Subject: RE: Planning Application No. A/NE-STK/36 --- Proposed Temporary Drone Training Centre with Ancillary Facilities for a Period of 3 Years

Application for Planning Permission for Proposed Temporary Drone Training Centre with Ancillary Facilities for a Period of 3 Years at Lots 1368(Part), 1369, 1371, 1372, 1373, 1376, 1377, 1378(Part), 1379, 1381, 1382, 1383, 1384, 1385, 1392, 1393, 1394, 1395, 1396, 1397, 1398(Part), 1399(Part), 1400(Part), 1401, 1402(Part), 1403 and 1404 in D.D. 41 and Adjoining Government Land, Tong To Ping Tsuen, Sha Tau Kok, N.T.

(Application No. A/NE-STK/36)

Table 1: Responses to Comments from Government Departments and the Public on Planning Application No. A/NE-STK/36 (8.9.2026)

Figure 4B

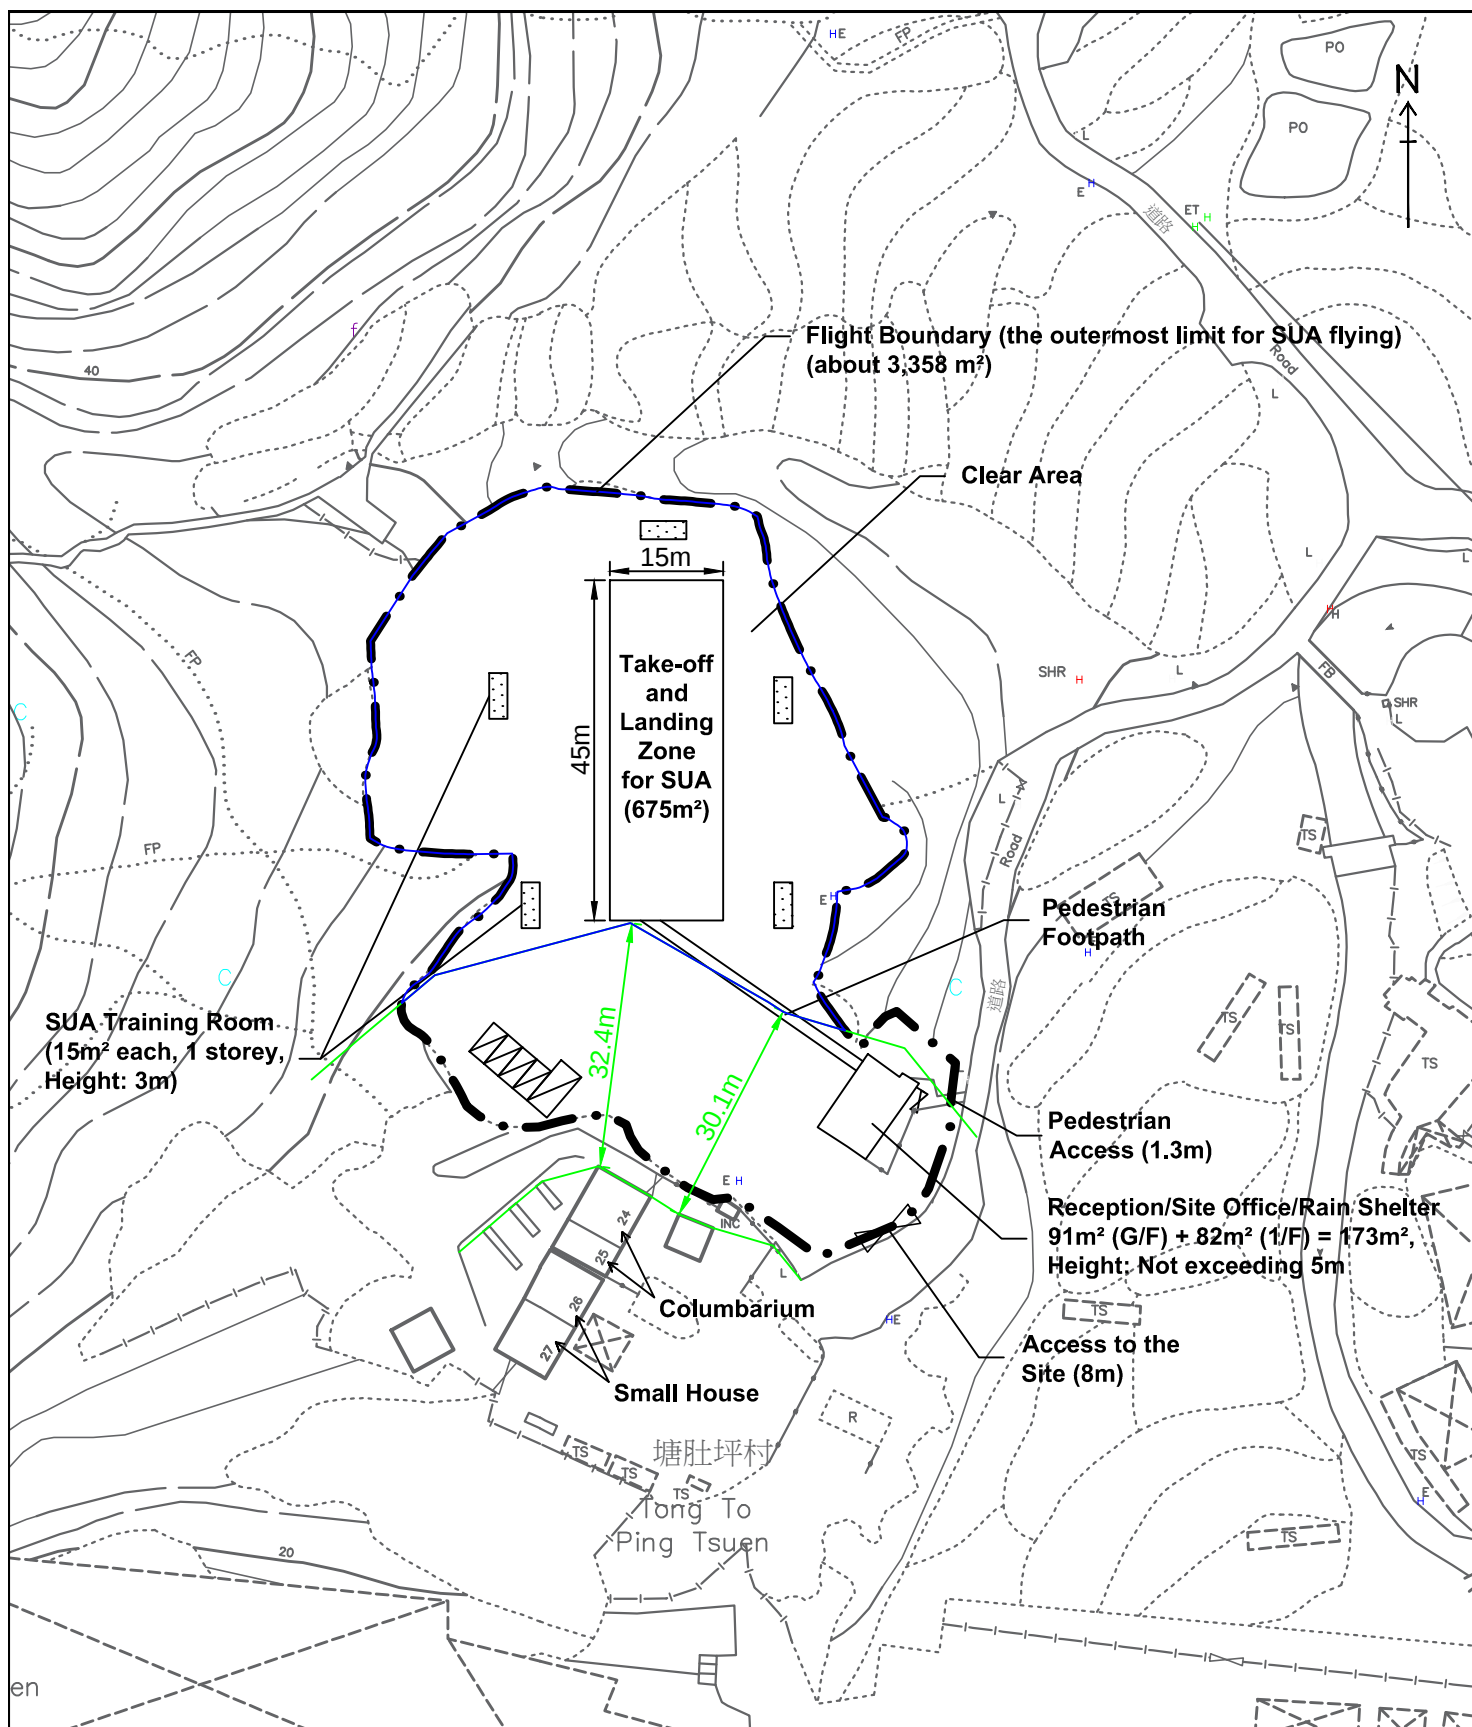
COMMENTS	RESPONSES
1. Transport Department	
(1) Our previous comment regarding the proposal on the vehicular access arrangement for the ingress and egress routes has not been addressed.	(1) The attached Figures 5A and 6A provide the updated swept path analysis, and Figure 4B shows the updated layout plan. The 2.0m level difference will be overcome by a graded ramp using cut-and-fill without requiring excessive land or major roadworks. The driveway will rise gradually with a maximum gradient of 1:10, which is within the acceptable limit for private cars and 16-seat minibuses. The parking spaces will move northwards to create a 35m distance between the ingress/egress point and the parking area for vehicular access. A speed signage of 5 km/h will be placed at the entry point to ensure vehicles slow down before accessing the site.
